STAFF REPORT

Agenda Title: For Possible Action: Discussion and possible action regarding an application from Andersen-Colard Ranch Enterprises, LLC ("Applicant") concerning a tentative subdivision map (SUB-2022-0374) known as Andersen Ranch West, to create 61 single-family residential lots and a 50.33-acre remainder parcel with an existing residence on an ±80.53 acre site zoned Single Family 1 Acre ("SF1A") and Single Family 12,000 Square Feet ("SF12"), located west of Ormsby Boulevard and north of Kings Canyon Road, Assessor's Parcel Numbers ("APNs") 009-012-20 and -21. (Heather Manzo, hmanzo@carson.org)

Staff Summary: The Applicant is requesting to subdivide an ±80.53-acre site consisting of two parcels into 61 single-family residential lots with a minimum lot size of ±14,380 square feet, 3.82 acres of common open space, and a 50.33-acre remainder parcel with an existing residence, using the provisions of Carson City Municipal Code ("CCMC") Chapter 17.10 - Common Open Space Development. The Board of Supervisors ("Board") is authorized to approve, conditionally approve or deny a tentative subdivision map. The Planning Commission recommended denial of the tentative subdivision ma

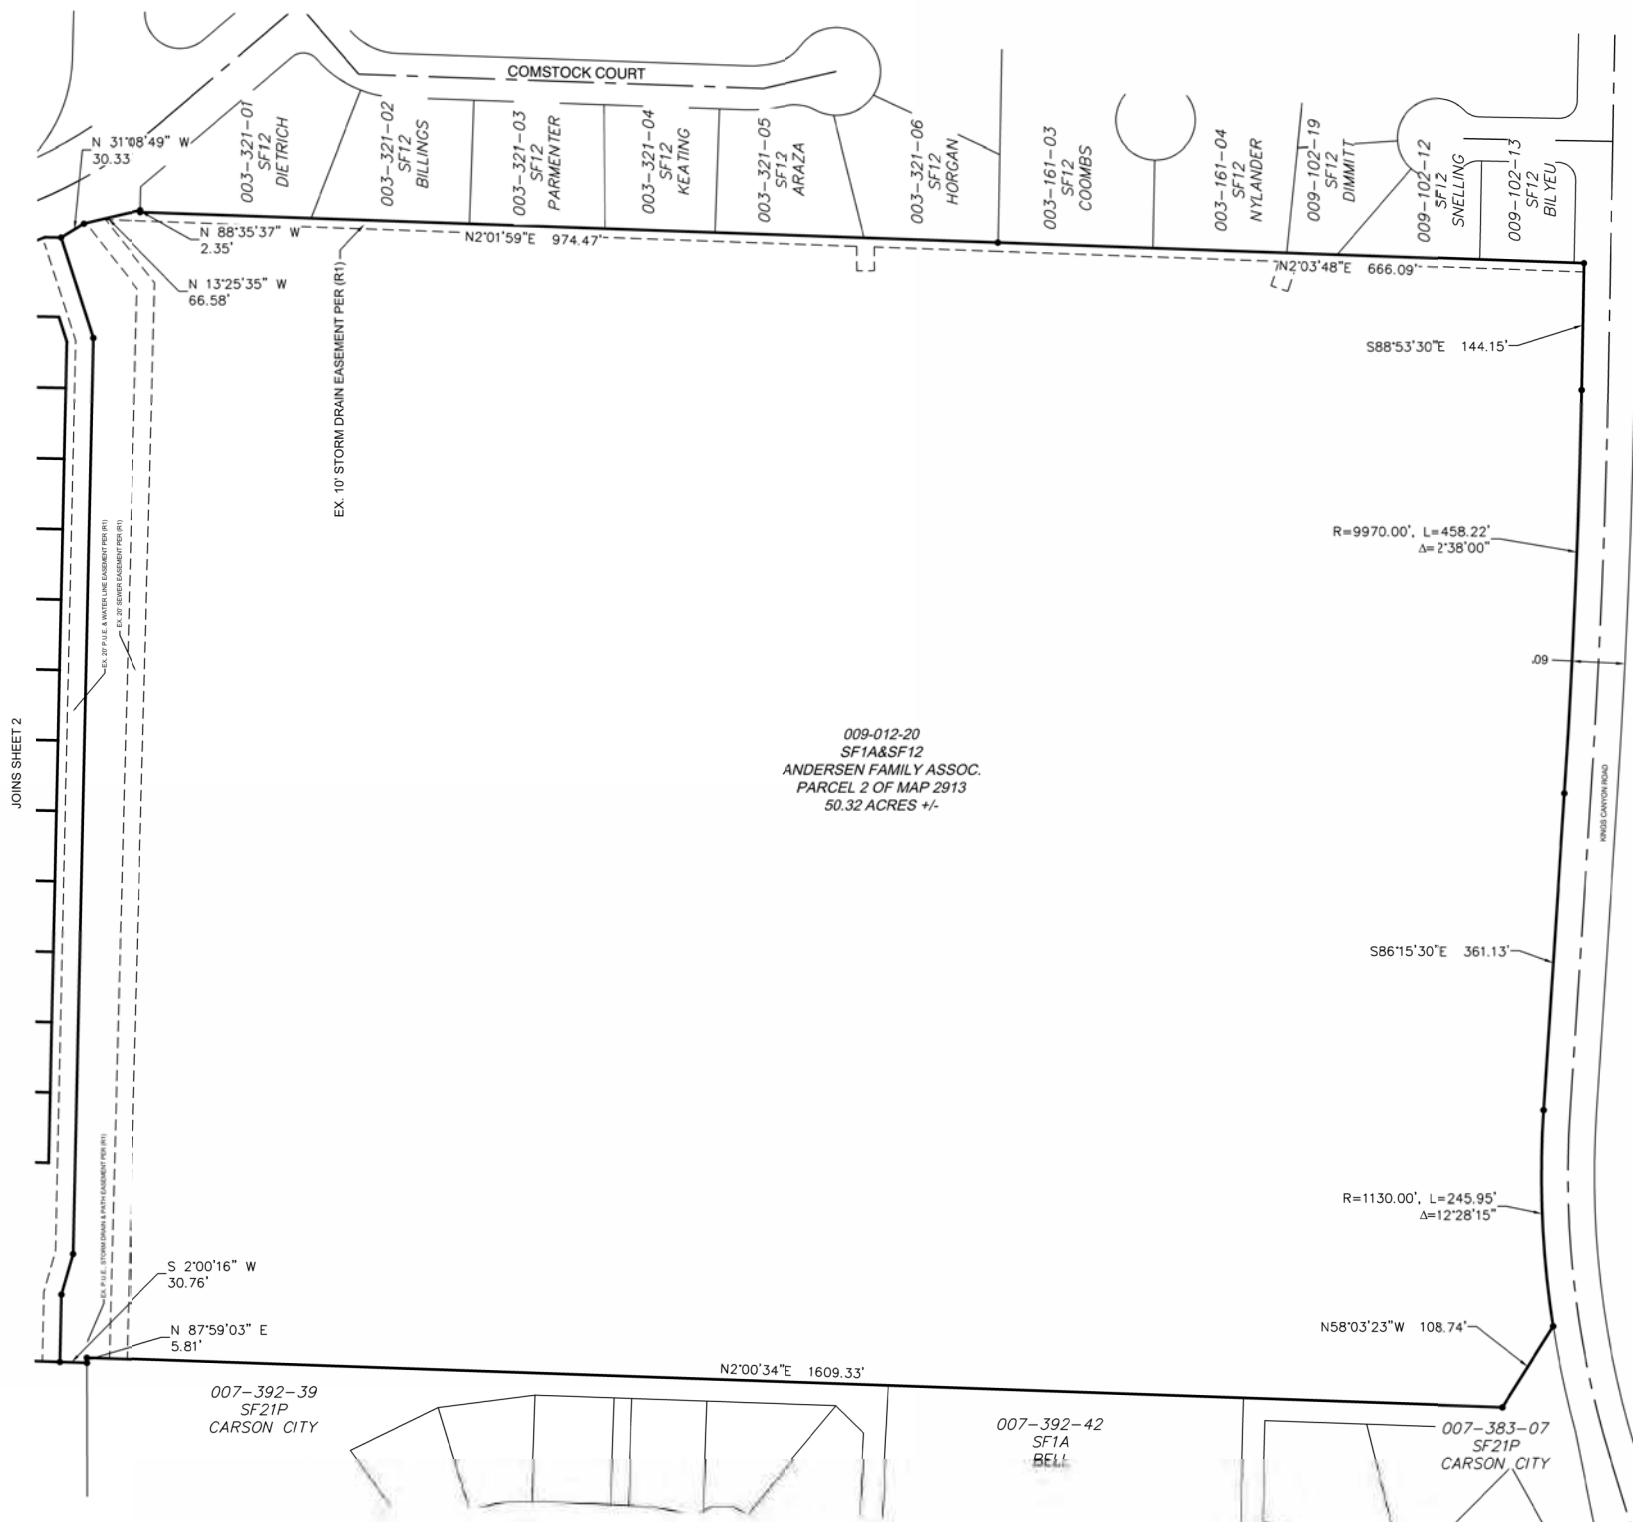
The revised tentative subdivision map removes one of the two access roads on Ormsby Boulevard and aligns the roadway with the proposed roadway for the Ash Canyon development located on the east side of Ormsby Boulevard. The Applicant has stated that there is sufficient remainder parcel frontage on Ormsby Boulevard to accommodate secondary access at the time the remainder parcel is proposed for development.

Hi Heather – please see attached for the revised civil TM sheets reflecting the site plan change to have one connection to Ormsby, better aligning with the Ash Canyon subdivision to the east.

REFERENCE SHEET C2.1

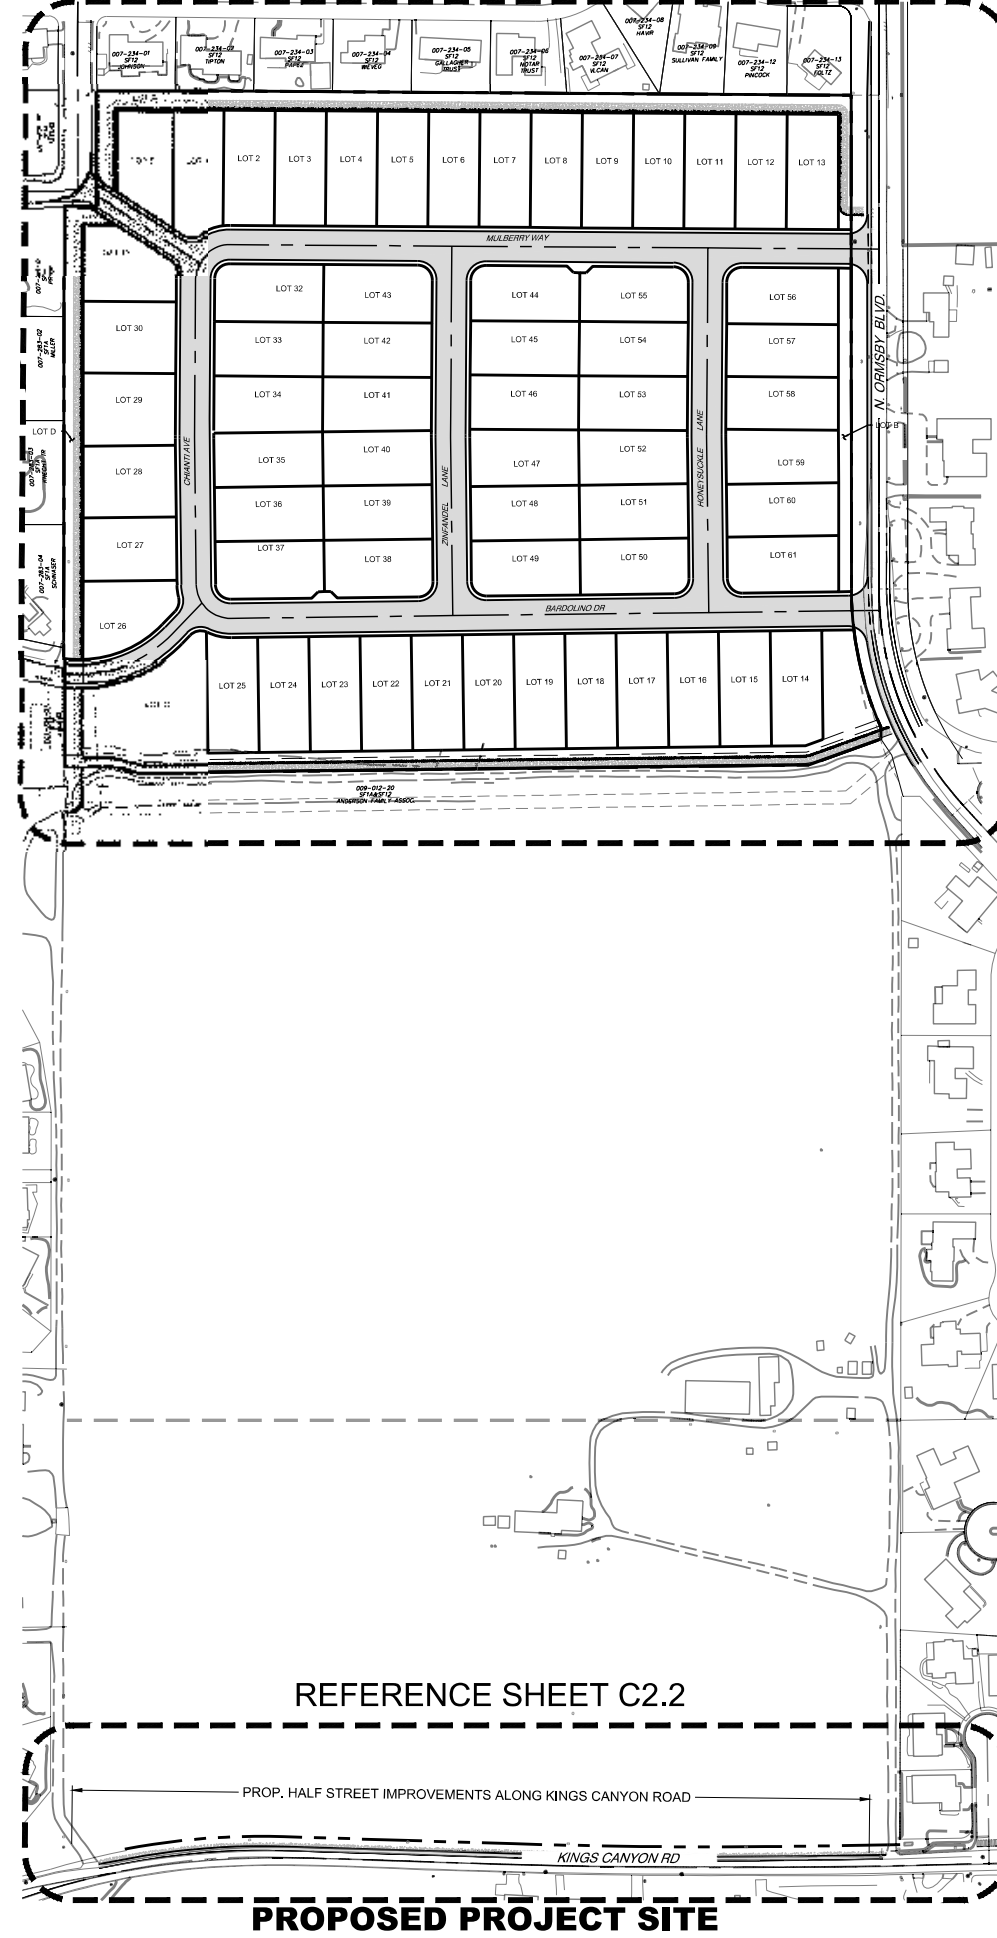
Response: The minimum lot width for Lot Size less than 1-acre, per CCMC 17.10.030, of 80-ft has been provided on the proposed 61 lots. Minimum setbacks per CMCC 17.10.030 are shown on the detail provided on Civil sheet C2.1.

Response: Half street improvements have been shown on Civil sheet C2.1. Due to minimum street width and the pedestrian shared use path width requirements, there will be no path along the project frontage and only the proposed sidewalk along North Ormsby.
